D/DRC Case

914 Gregg Street

DESIGN/DEVELOPMENT REVIEW COMMISSION
DESIGN REVIEW DISTRICT
HISTORIC AGENDA
EVALUATION SHEET
Case #7

NATURE OF REQUEST: Request for a Certificate of Design Approval for exterior changes.

February 1967 – prior to porch enclosure

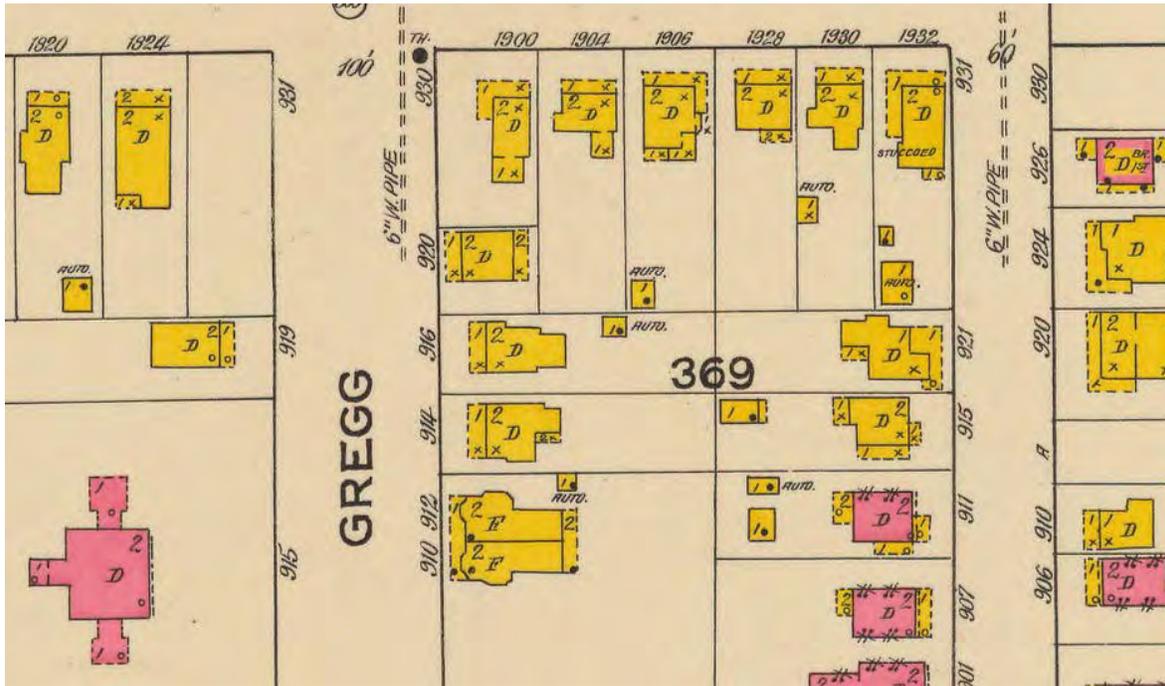
The ca. 1912 American Foursquare house located at 914 Gregg Street is a contributing structure in the local University Hill Architectural Conservation District and the University Neighborhood Historic District, which is listed in the National Register of Historic Places. The applicant has owned this house for almost 39 years, and during this time the house has had several exterior alterations. The earliest photograph staff could find of the house is from 1967, in which it appears to be unaltered architecturally. In the photograph the house features a prominent dormer, two large chimneys, 16/1 windows, an open porch with square columns, asymmetrical paired entry doors, and simple porch railings. Staff has included the 1967 photograph with this evaluation along with photos taken in 1993 and 2014 for comparison. The 1993 photograph shows that the front porch was enclosed and faux shutters were installed. The 2014 photograph shows the house's current condition. Changes made between 1993 and 2014 include replacement windows with pane configurations that do not match the originals, faux shutters removed, skylights added to the front porch roof, and the two windows on the front of the porch were changed to French doors with fanlights. A brick wall was also installed in the front yard of the property in 1996.

June 1919 Sanborn Fire Insurance Map

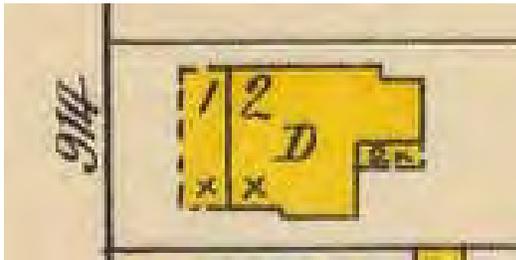
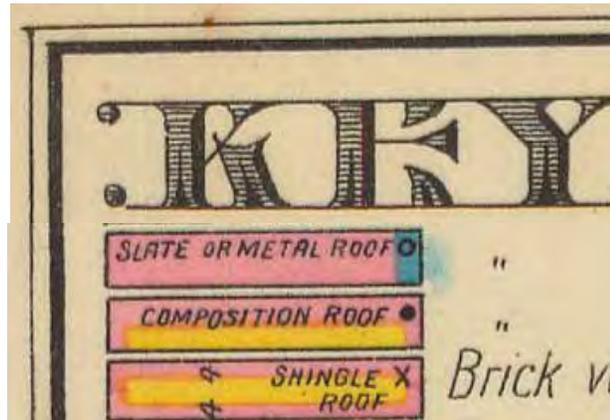
As shown on the 1919 Sanborn map included with this evaluation, the historical roofing material for 914 Gregg Street was most likely wood shingles. As such, the original roofing material is no longer extant. The house currently features asphalt shingles on both the main roof and the 1-story porch roof.

Most of the houses on Pendleton and Gregg streets featured wood shingle roofs as indicated by "X" marked on the building footprints above (see key below).

MEDALLION-LOK

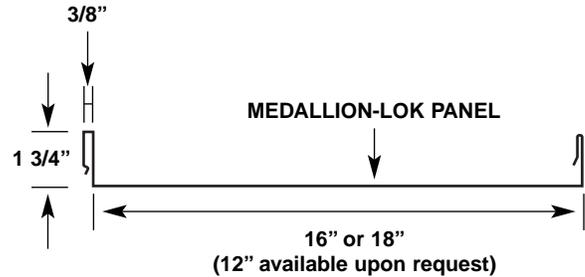
The applicant's proposal to replace the existing tabbed asphalt shingles on the 1-story front porch with a standing seam metal roof is not consistent with this guideline. The composition, size, shape, color, and texture of the proposed standing seam metal roof are not compatible with the existing asphalt shingles on the main roof. Metal is often used when the slope of a roof does not provide enough pitch to allow proper water runoff. The pitch of this roof, however, is consistent with other American Foursquare type houses in the district and does not require a metal roof to be water tight. The three skylights installed in the front porch roof are atypical for this type of house, and may be a potential source for water infiltration if not flashed or sealed correctly. If problematic, the skylights may be removed to minimize the risk of future water infiltration issues. Staff recommends the use of standard asphalt/fiberglass shingles for the front porch as there should not be any issues with water infiltration providing that the manufacturer's recommendations for waterproofing and installation are followed correctly.

*Staff finds that the proposal does not meet Section 5 – Roof Pitch/Material and **does not** recommend granting a Certificate of Design Approval.*
